Executive Director's Recommendation

Commission Meeting: April 2, 2026

PROJECT New Stadium at RFK Campus 2400 East Capitol Street, NE Washington, DC	NCPC FILE NUMBER 8721
SUBMITTED BY Mayor of the District of Columbia, RFK Stadium Project Management Office	NCPC MAP FILE NUMBER 8.40(38.00)46185
REVIEW AUTHORITY District Projects Outside the Central Area per 40 U.S.C. § 8722(b)(1)	APPLICANT'S REQUEST Approval of preliminary site and building plans
	PROPOSED ACTION Approve preliminary site and building plans with comments
	ACTION ITEM TYPE Staff Presentation

Approves preliminary site and building plans for a proposed new stadium and surrounding site improvements on the Robert F. Kennedy (RFK) Memorial Stadium Campus, located in Washington, DC.

Loading and Deliveries

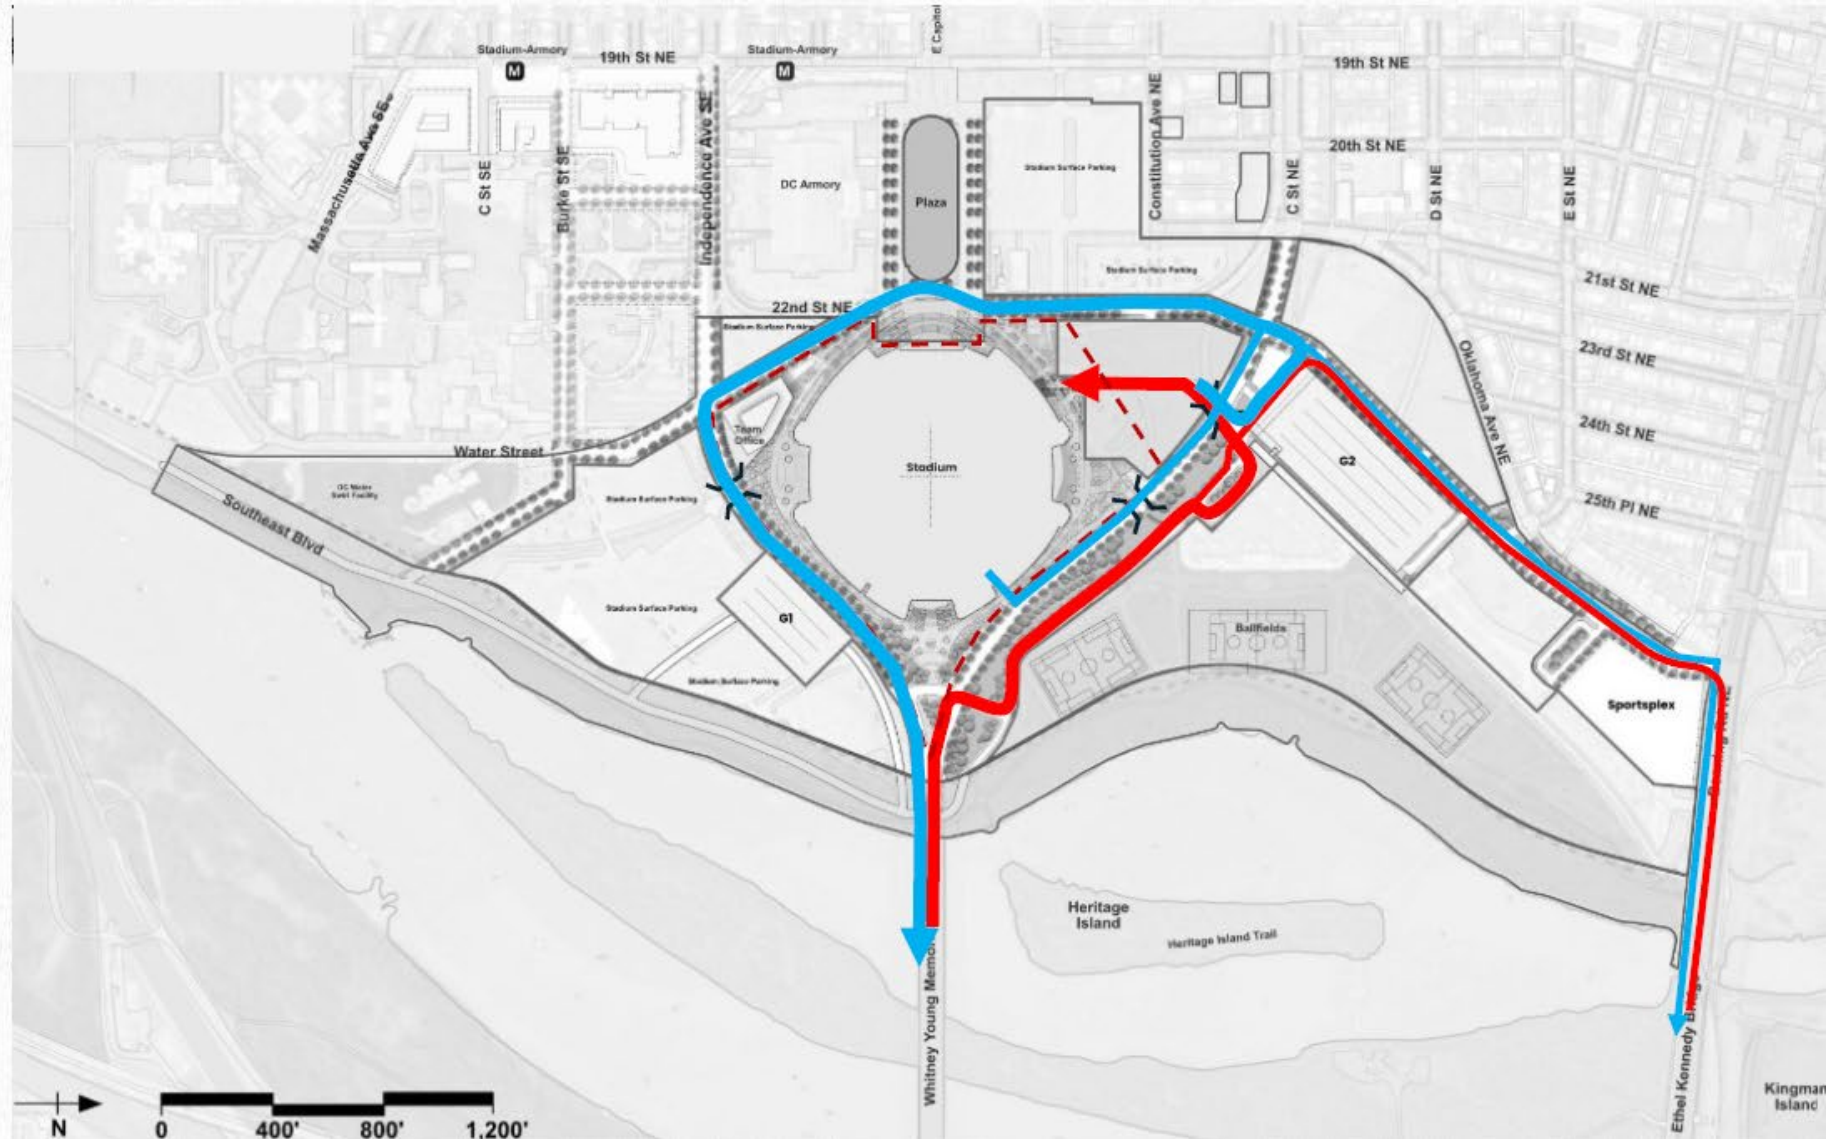
Notes the proposal aims to avoid service entry impacts to the design of the stadium building by locating the primary loading dock ingress and egress through a north tunnel under the stadium grounds.

Recommends screening the loading tunnel entry from pedestrian pathways and seating areas with vegetation.

As noted at the Commission meeting, loading and service areas often create a utilitarian side to urban buildings which would be difficult to disguise in a prominent stadium that is highly visible from all angles. The proposal aims to address this issue by locating the primary loading dock ingress and egress through a north tunnel under the stadium grounds, avoiding service entry impacts to the design of the stadium building. However, to also prevent visual impacts of the tunnel entry on the experience of the stadium landscape, staff recommends the **Commission recommend**

screening the loading tunnel entry from pedestrian pathways and seating areas with vegetation.

Tree Preservation and Replacement

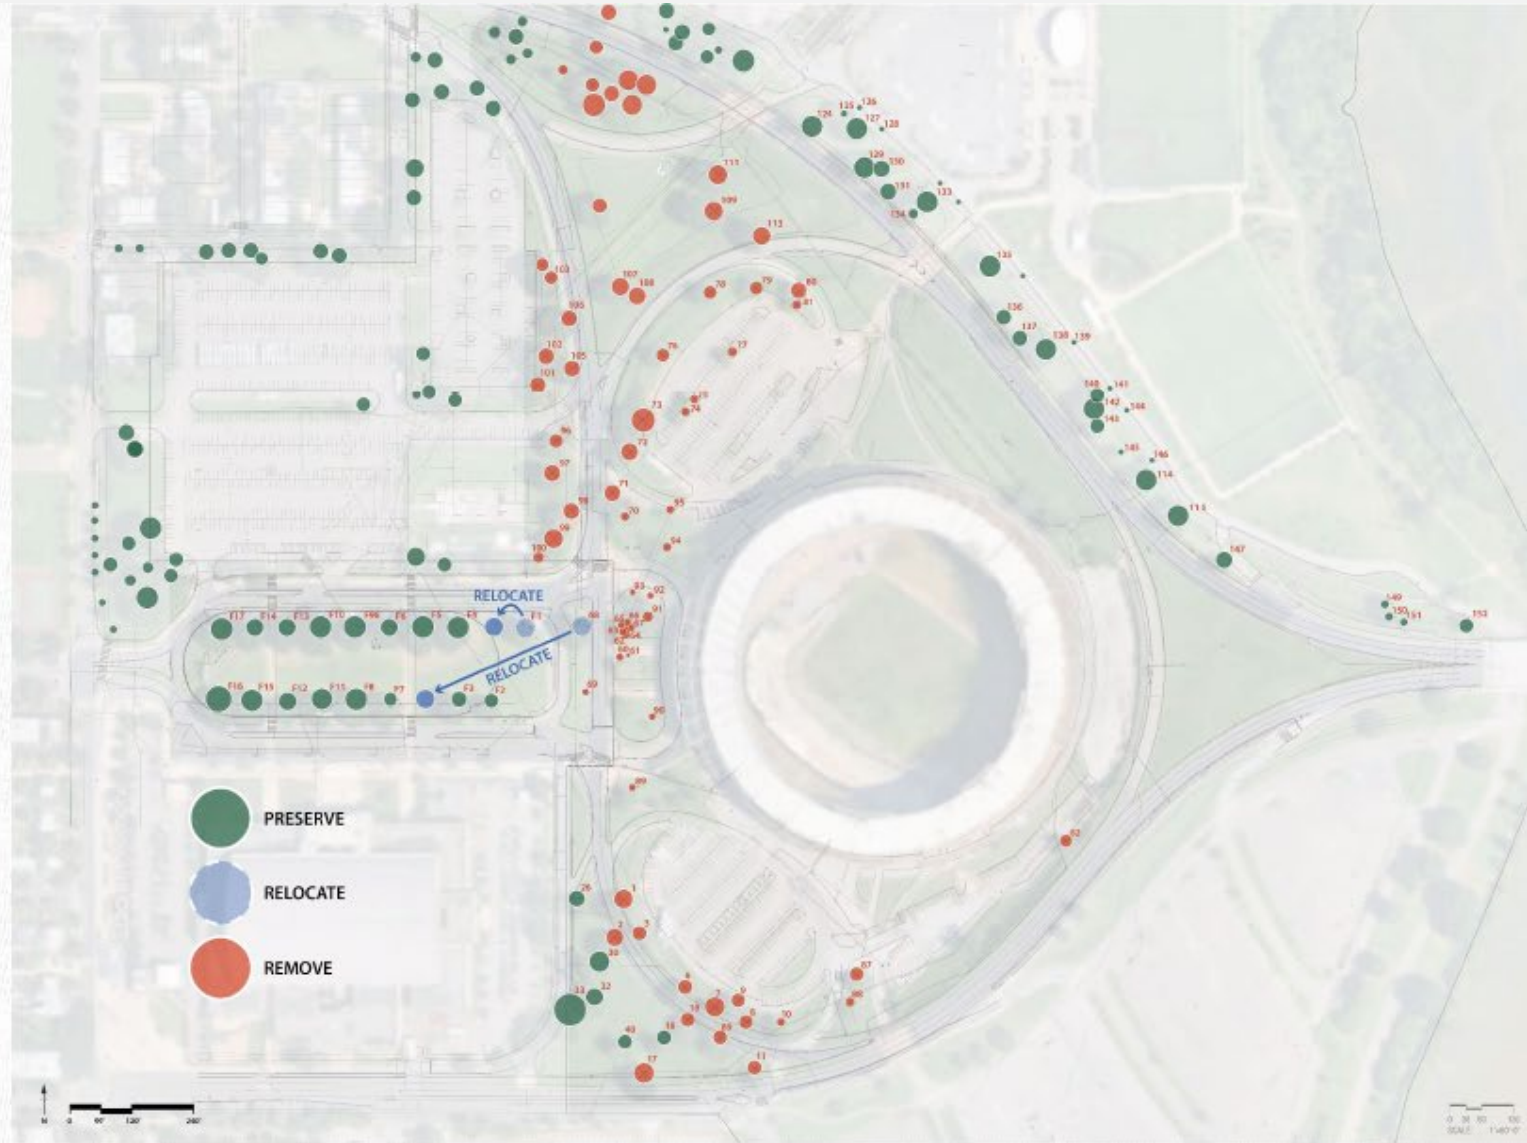
The preliminary submission includes additional information regarding tree preservation and replacement. According to the applicant most of the existing trees on site are in poor or declining condition, and these compromised trees will be removed with the exception of the allée of healthy trees west of the stadium in the festival plaza and north of the stadium along C Street, NE. The applicant plans to meet the District's project requirements regarding tree preservation and replacement and to generally conform with the intent of policies in the Comprehensive Plan Federal Element. The project will protect remaining trees and replace trees that are required to be removed with primarily native or well-adapted species on site where feasible. Two large elm trees, which are Heritage Trees, will be carefully preserved and relocated within the Festival Plaza.
